MANDATORY SERVICE BULLETIN

NO. MSB-42-024/3

Installation of Propeller System Check valve Bracket

WI-MSB-42-024

1	Remove upper LH cowling according to the AMM
	Remove nut of coolant tank mounting (see Pos 1, picture 1)
 <p style="text-align: right;">Picture 1</p> <p>Pos 1 Pos 2 Pos 3</p>

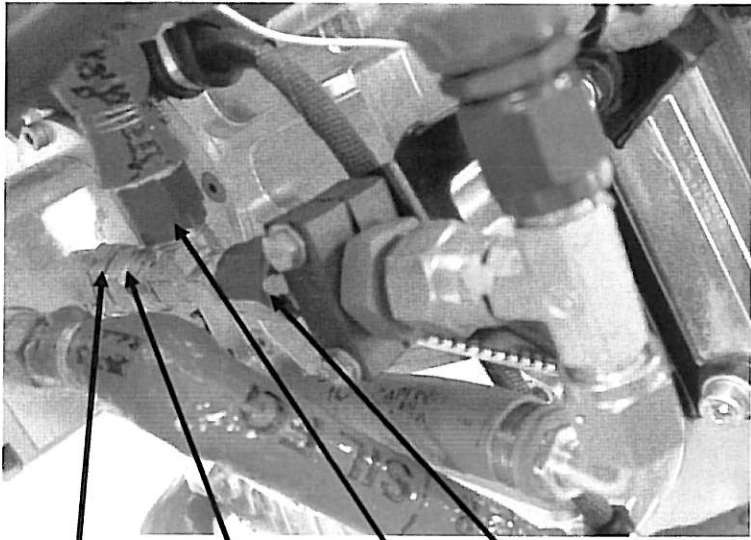
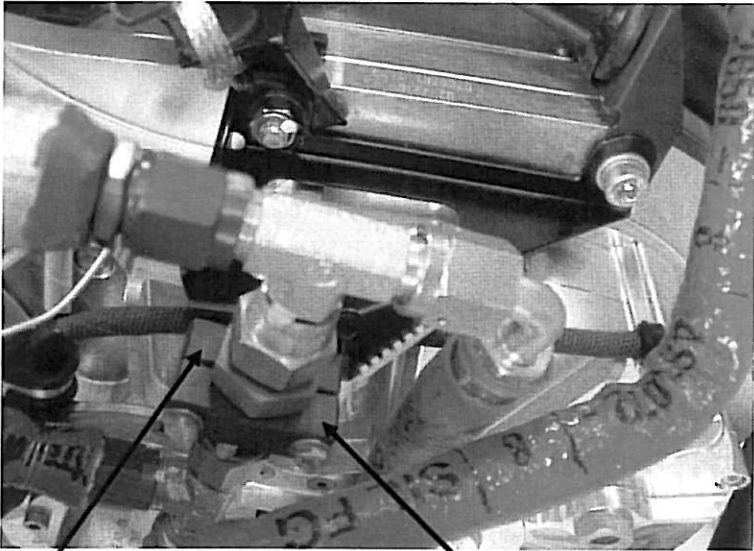
3	Bring valve stiffener (see Pos 2, picture 1) in position and fix it with the nut and the bolt (Pos 1 and Pos 2, picture 1)
4	<p>Disconnect Pos 2 from Pos 1. Remove Fitting Pos 1 (Adapter P/N 02-6120-16057R1) and gasket. Install new gasket (02-7210-07294R1) and fitting (Adapter 02-7210-07292R1) (tightening torque 30 Nm). Connect Pos 2 to the installed fitting and close it only so far that the connection is flexible. Loosen fittings position 3 and 4, picture 2 only so far, that the connections are flexible.</p>  <p style="text-align: right;">Picture 2</p> <p>Pos 1 Pos 2 Pos 3 Pos 4</p>
5	<p>Bring first half of valve clamp (see Pos 1, picture 3) into position between stiffener and valve.</p>  <p style="text-align: right;">Picture 3</p> <p>Pos 1 Pos 3</p>
6	Bring second half of valve clamp (see Pos 2, picture 3) into position in front of the valve.

7	Attach the valve clamps to the stiffener with the screws, washer and nuts. Tighten the screws. If the fittings are loose enough (see step 4) the valve should not be distorted.
8	Tighten the fittings position 1, 2 and 3, picture 2 use standard torque according to the AMM
9	Clean working area and check for foreign objects.
10	Perform ground run and check for leakage in accordance with AMM
11	Install upper LH cowling in accordance with AMM
